# Upgrade HVJB to Charger Harnesses

<b>Classification</b>	Repair Bulletin	<b>Section/Group</b>	44 - High Voltage System	<b>Country/Region</b>	Europe, APAC
<b>Year</b>	2012-2014	<b>Model</b>	Model S	<b>Version</b>	All

This Service Bulletin supersedes SB-14-44-003 R2, dated 30-May-14. Each content change is marked by a vertical line in the left margin. Discard the previous version and replace it with this one.

**Figure 1 (Dual Charger configuration shown)**

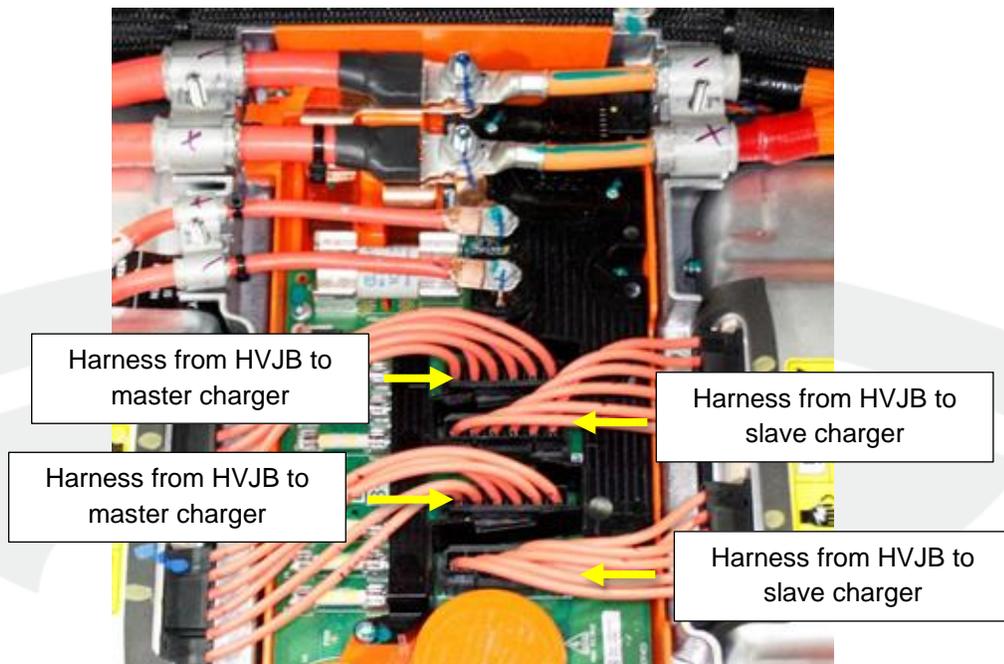
- Replace the 2 harnesses that connect the HVJB to the master charger (Figure 1). If the vehicle is equipped with dual chargers, also replace the 2 harnesses that connect the HVJB to the slave charger.

**⚠ CAUTION:** The harnesses for the different chargers are visually similar and have similar part numbers. Ensure that the correct harnesses are installed in the correct location. Note that the harnesses to the master charger are slightly longer than the harnesses to the slave charger.

✓ **Figure 2**

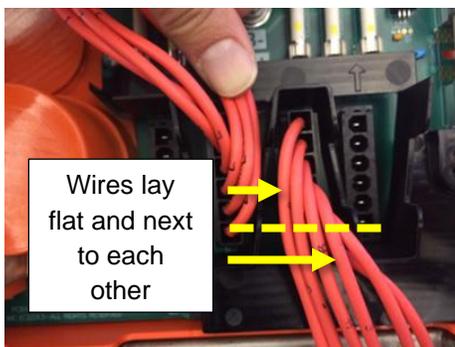
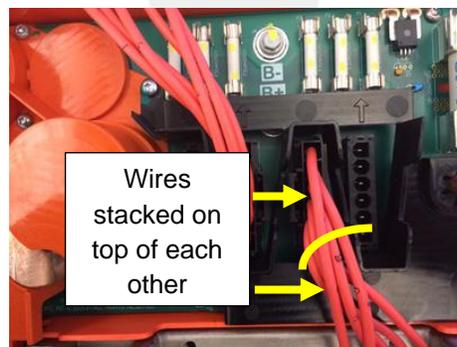
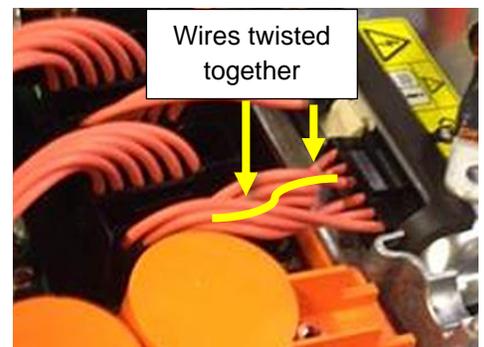
**⚠ CAUTION:** During installation, ensure that the harnesses are arranged neatly and are not twisted, and that they do not put unnecessary stress on the ports inside the HVJB or the charger (Figures 2–4).
